CITY OF PORT LAVACA

MEETING:	June 12, 2023	AGENDA ITEM
DATE:	06/8/2023	
TO:	HONORABLE MAYOR AND CITY COU	NCIL MEMBERS
FROM:	DERRICK SMITH, DEVELOPMENT SER	RVICES DIRECTOR
SUBJECT:	Consider recommendation from Plannin Conceptual plan and a Variance request Division 3-Off Street Parking and Loading for a Mixed Use development to be located a Parcel ID's#87353 and #87352	to the ordinance Chapter 48, g, Sec.48-106 and Sec. 48-107

Kevin and Sasha Nevarez are requesting approval of a variance for off-street parking due to site constraints.

Fig. 29 - Commerce Street District Improvements Plan

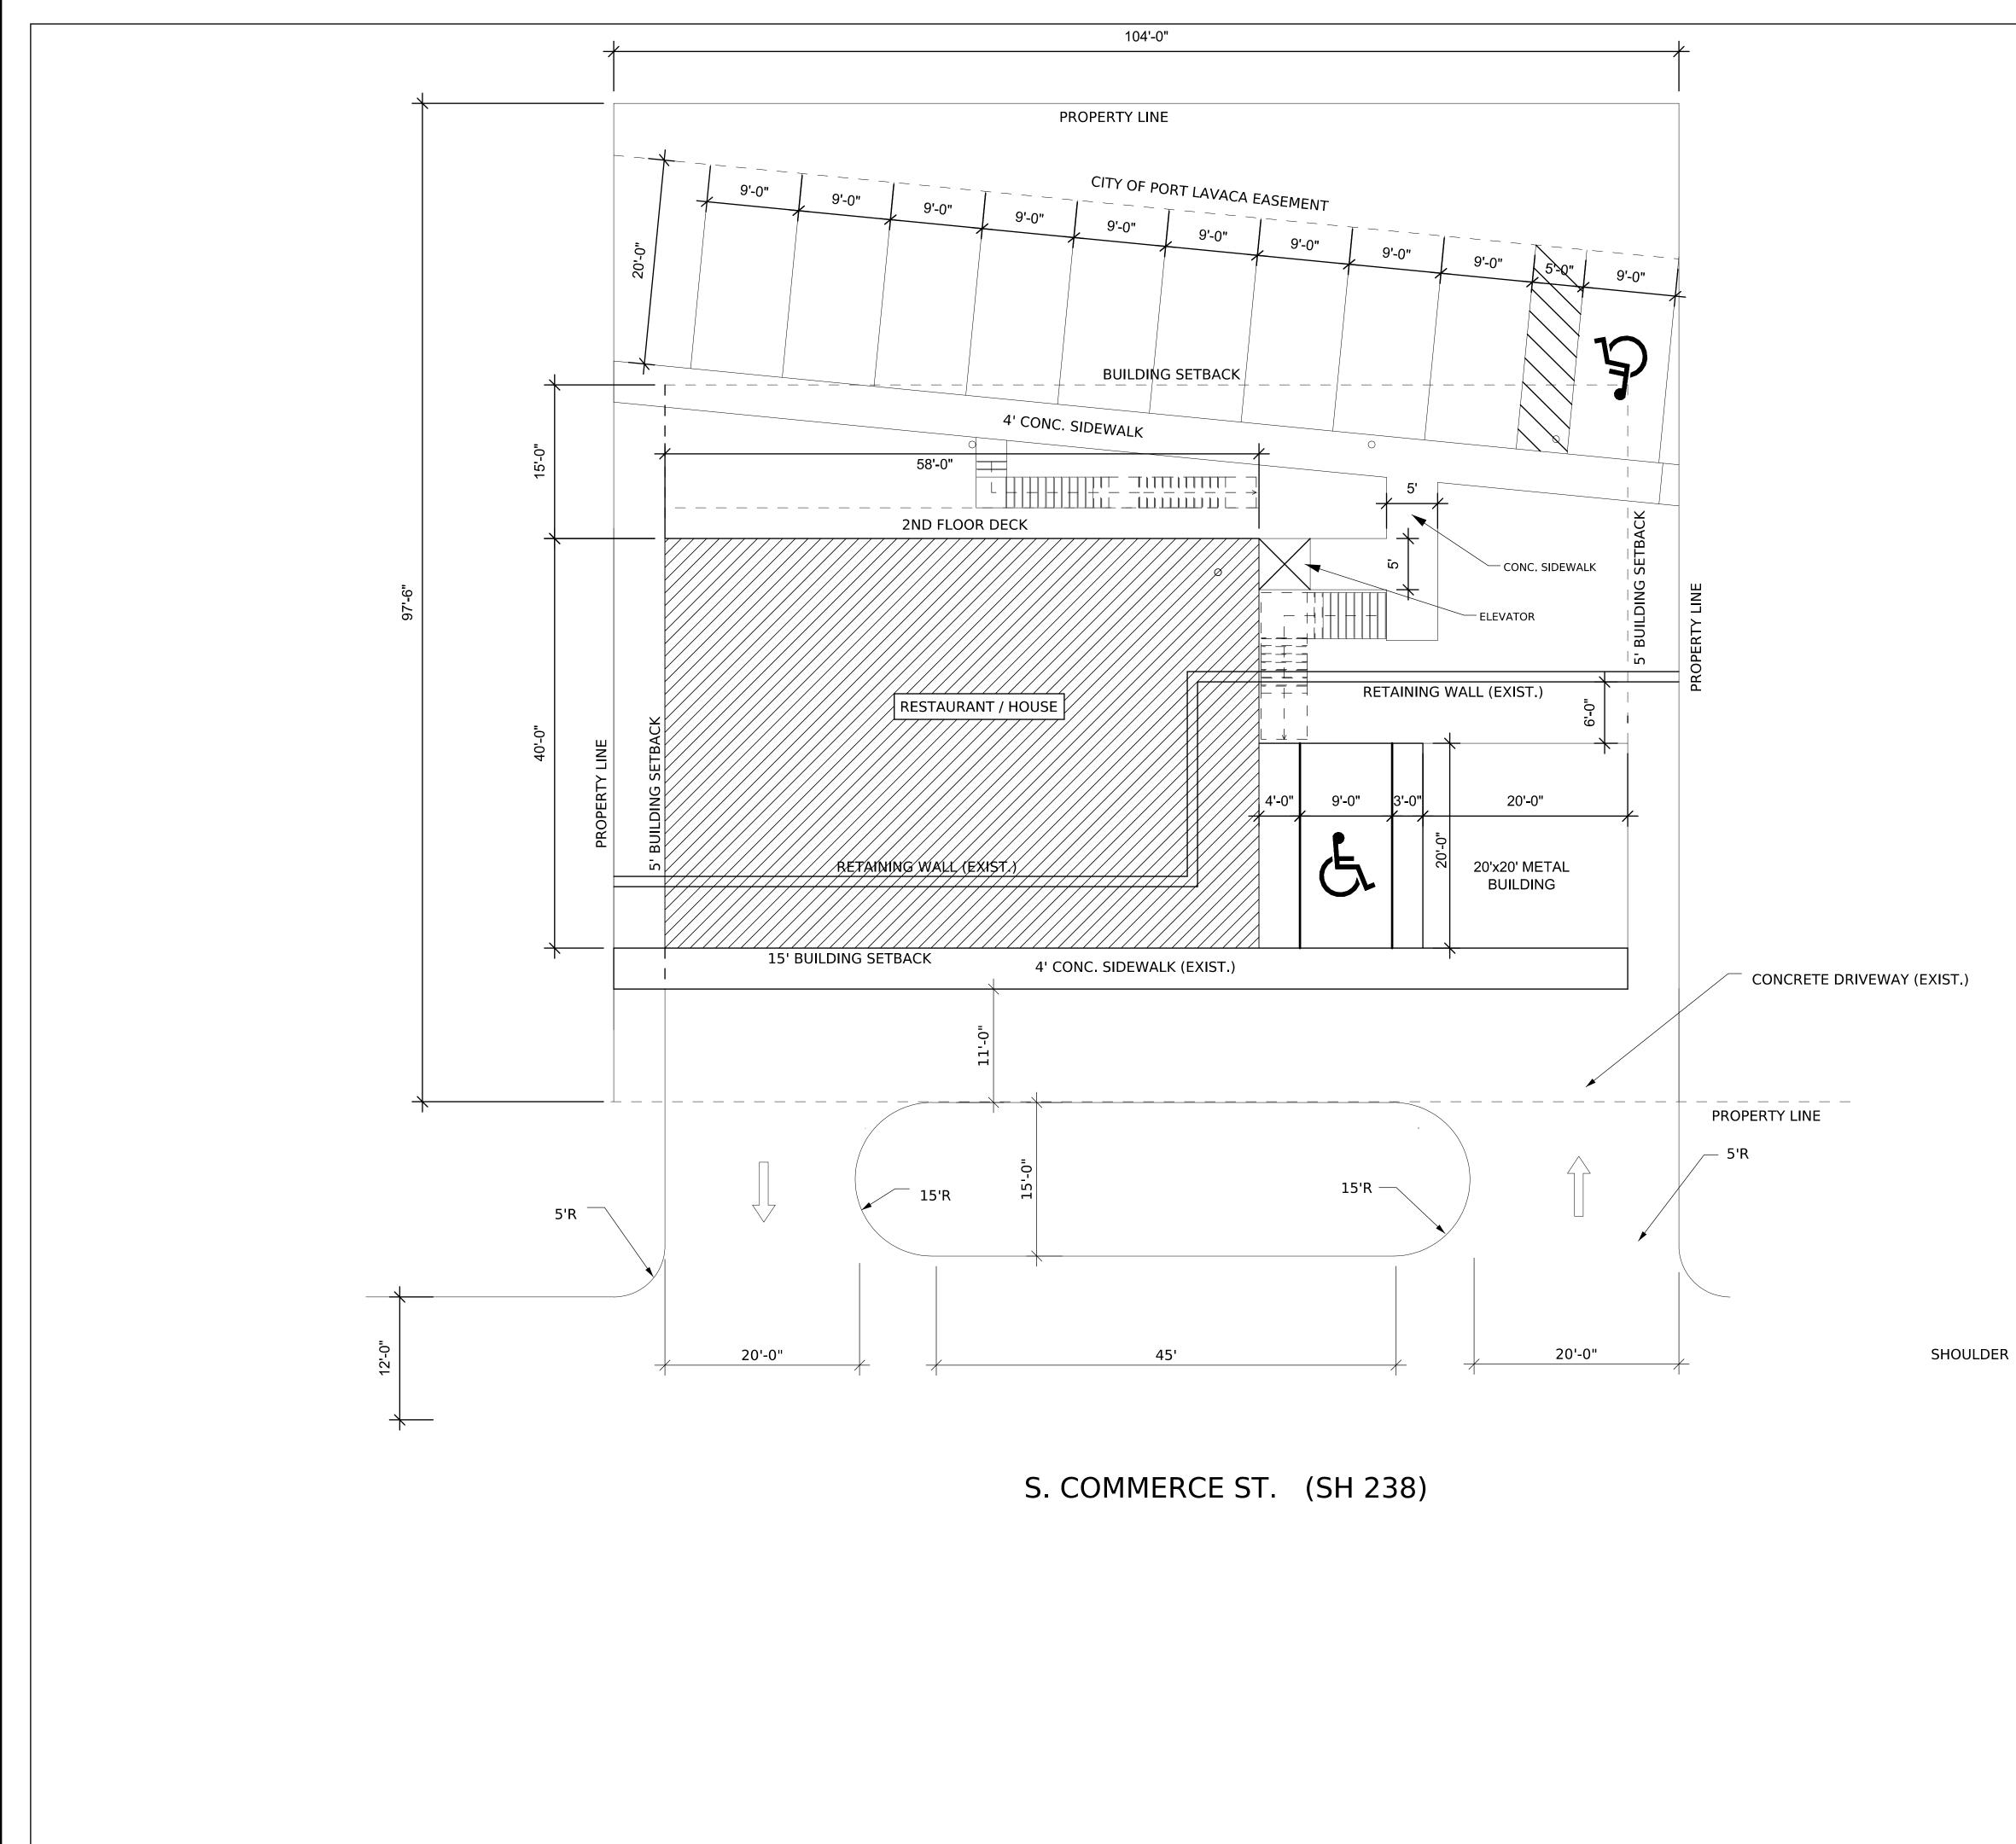
Development Services: This proposed Mixed Use Development is consistent with the Future Land Use Plan and the proposed Downtown Waterfront Mater Plan (see attached Fig 29 from the DTWFMP). As we discussed when reviewing the proposed Downtown Waterfront Masterplan, we need to rethink parking for new development in this Downtown area. Potential development in this Downtown area will often not have enough land area to accommodate 100% of the on-site parking required in our current parking ordinance. These businesses will need to count on some level of available public parking in the downtown area.

DRAWING: SITE PLAN

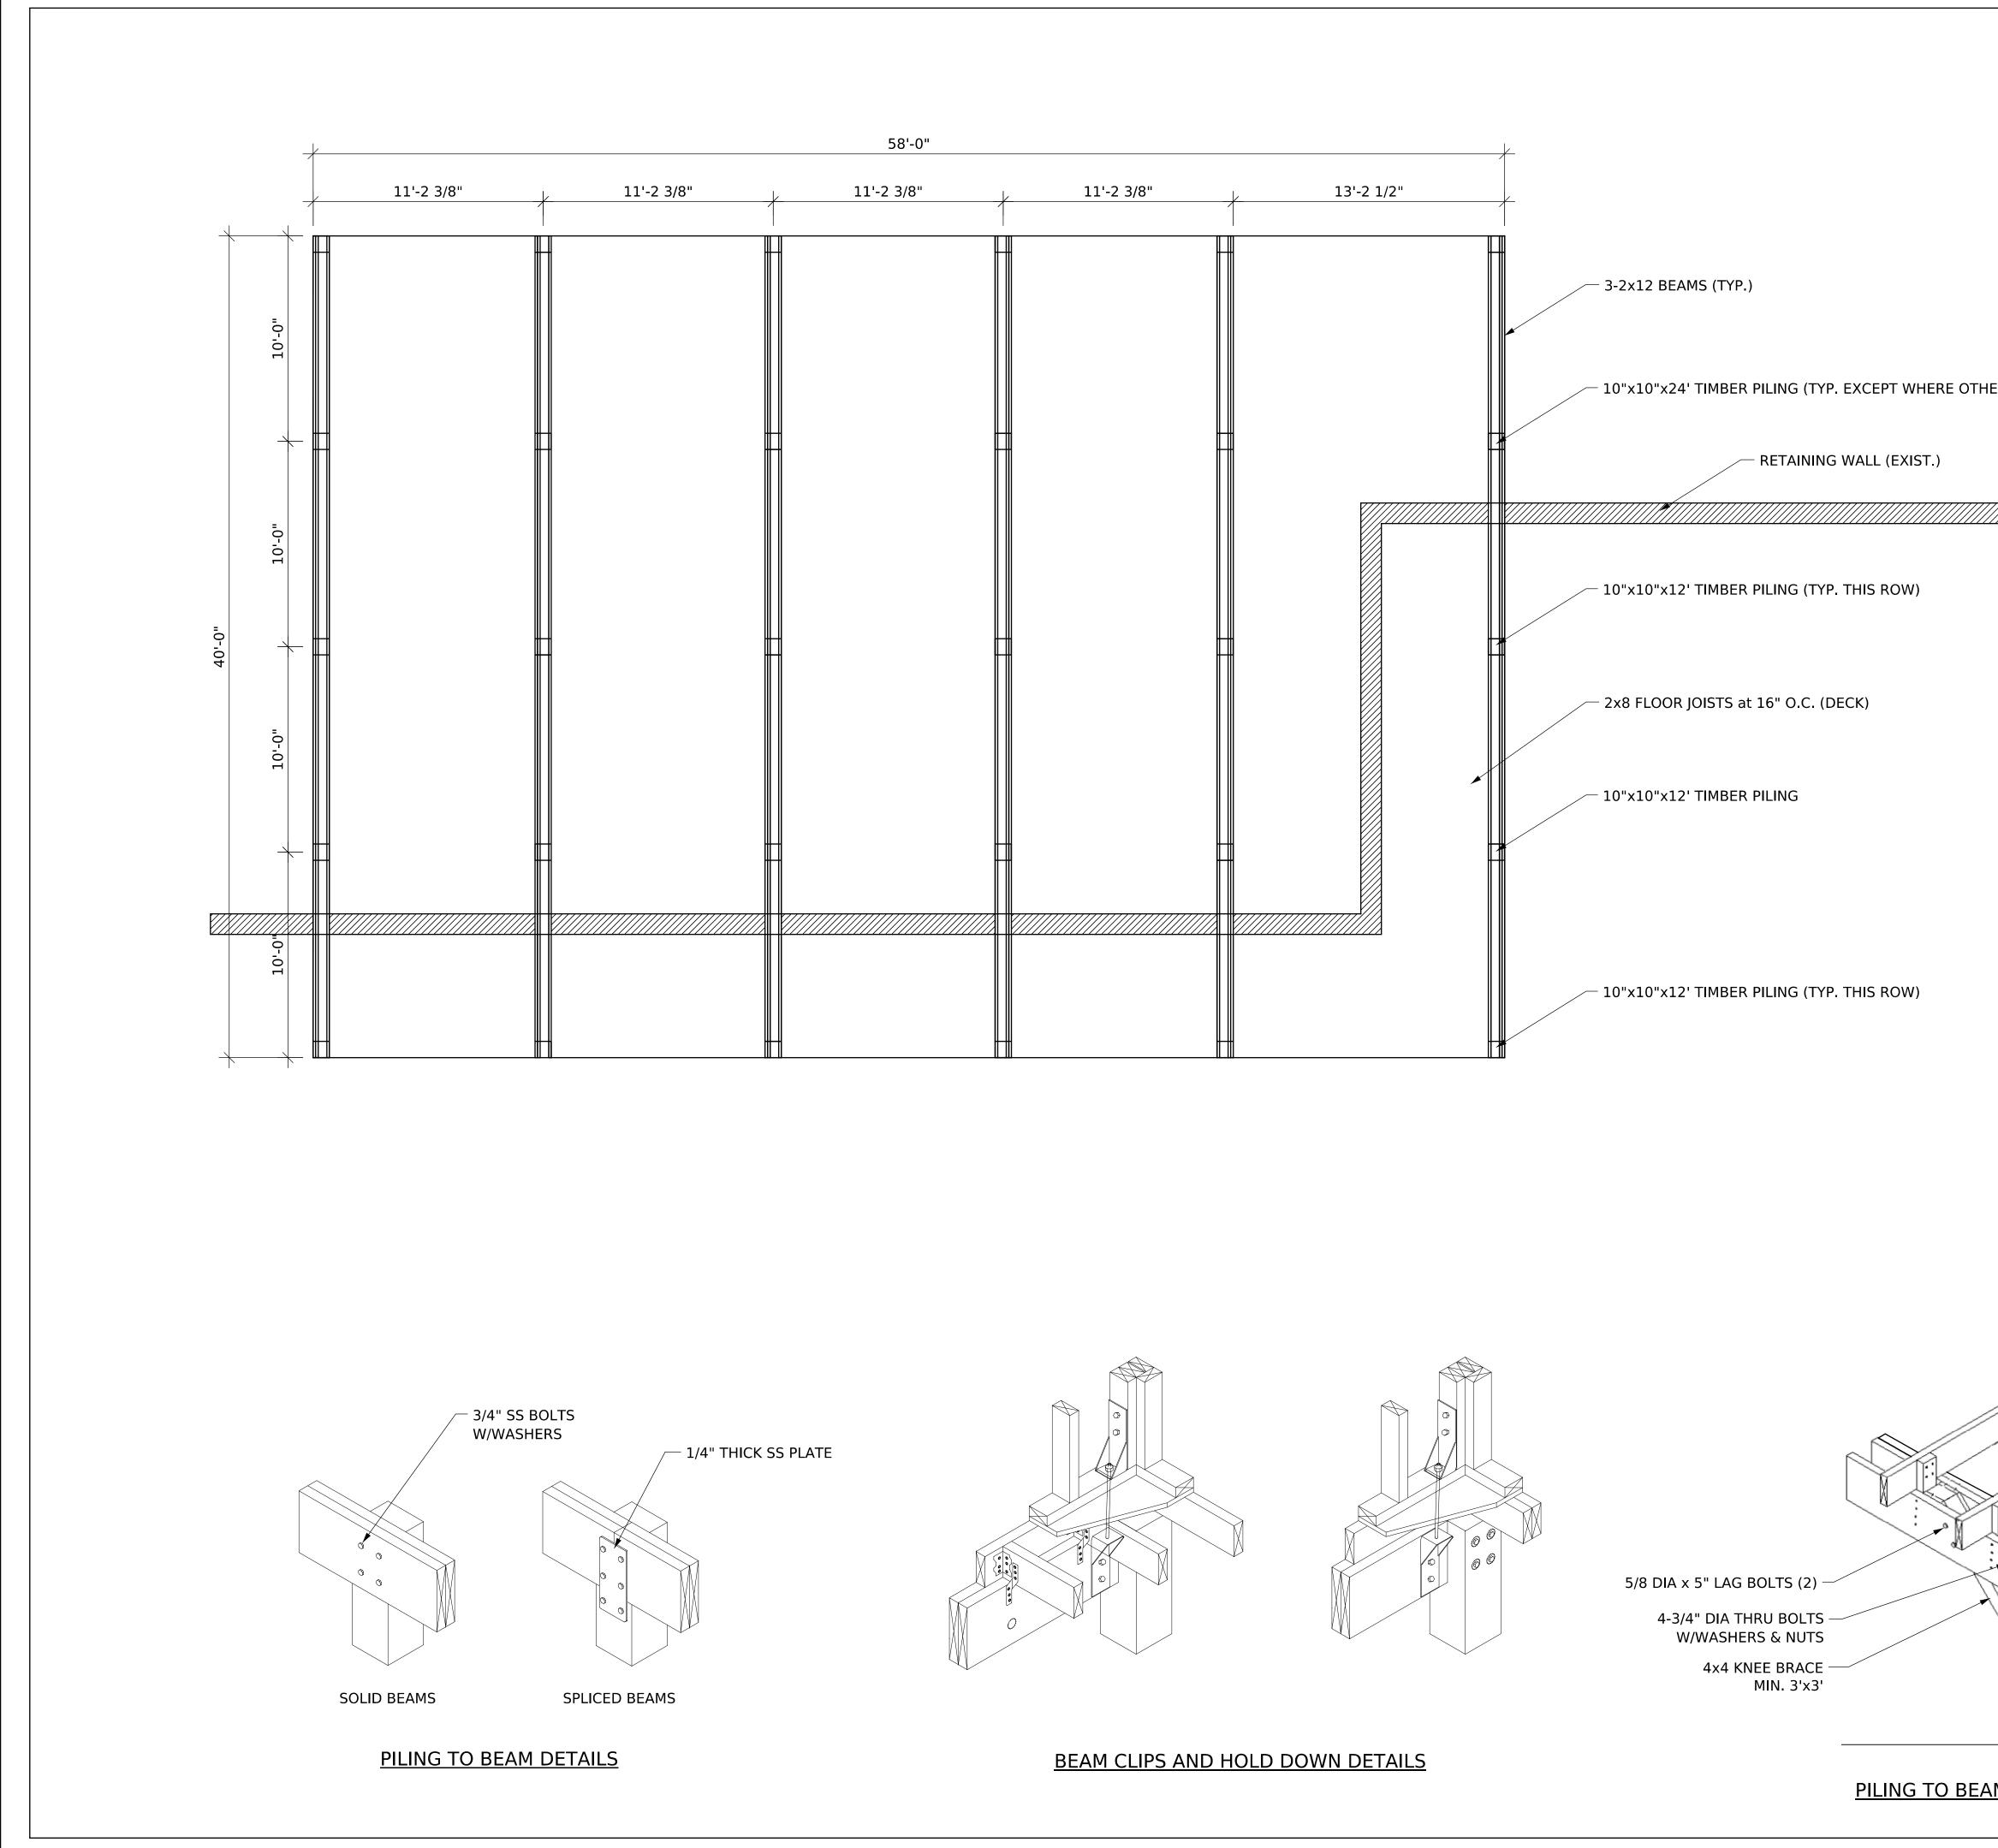
Engineering: Ensure ADA compliance and adequate parking

In consideration of the available public parking in the area, staff doesn't see an issue with reducing the required on site parking spaces.
